Access Compliance Report

Public Rights-of-Way

(Curb Ramps)

Intersection ID: 14461	Main Street: E_WORTHINGTON_AV	Cross Street: LYNDHURST_AV	Location: W
ADA ID: EFB3C9E3FD79	Ramp Type: Perp	Initial Pass/Fail: Fail	Overall Compliance: No
Codes/Mitigation Info/Possible Solution			Severity Score: 25
			Field Measurements/Component Compliance

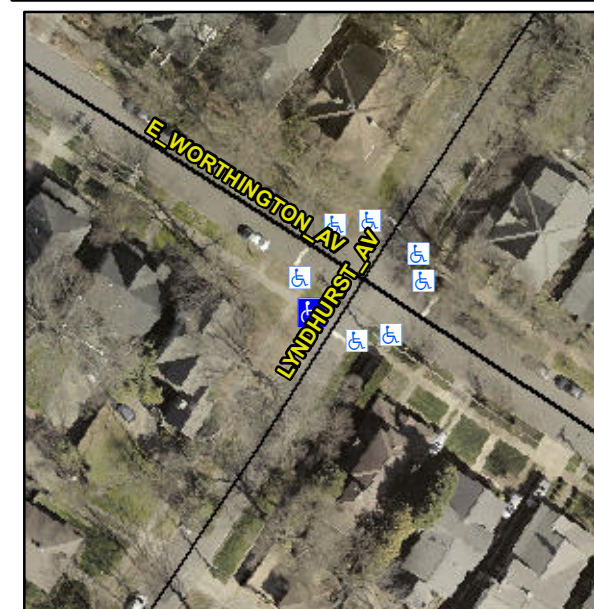
Not Found, R304.2.2, R304.5.3

Compliance	Description	Data	Compliance	Description	Data
N/A	Ramp Length (in)	66.0	No	Ramp Slope (%)	9.8
Yes	Ramp Width (in)	48.0	No	Ramp XSlope (%)	5.1
N/A	Flare Type LT	N/A	N/A	Flare Type RT	N/A
N/A	Flare Slope LT (%)	N/A	N/A	Flare Slope RT (%)	N/A
N/A	Flare Traversable LT?	N/A	N/A	Flare Traversable RT?	N/A
N/A	Landing Length (in)	N/A	N/A	DWS Provided?	N/A
N/A	Landing Width (in)	N/A	N/A	DWS Contrast?	N/A
N/A	Landing Slope (%)	N/A	N/A	DWS Length (in)	N/A
N/A	Landing X Slope (%)	N/A	N/A	DWS Full Width?	N/A
N/A	Landing Curb? (Y/N)	N/A	N/A	DWS Offset (in)	N/A
N/A	Shared Landing?	N/A			
N/A	Gutter Ponding?	N/A	N/A	Gutter Slope (%)	N/A
N/A	Gutter Lip Ht (in)	2.0	N/A	Gutter X Slope (%)	N/A
N/A	Painted X Walk1?	No	N/A	Painted X Walk2?	N/A
	X Walk 1 Direction	To SE		X Walk 2 Direction	N/A
N/A	X Walk 1 Width (in)	N/A	N/A	X Walk 2 Width (in)	N/A
	X Walk 1 Slope (%)	2.2		X Walk 2 Slope (%)	N/A
	X Walk 1 X Slope (%)	3.9		X Walk 2 X Slope (%)	N/A

Remove & Replace Entire Ramp.
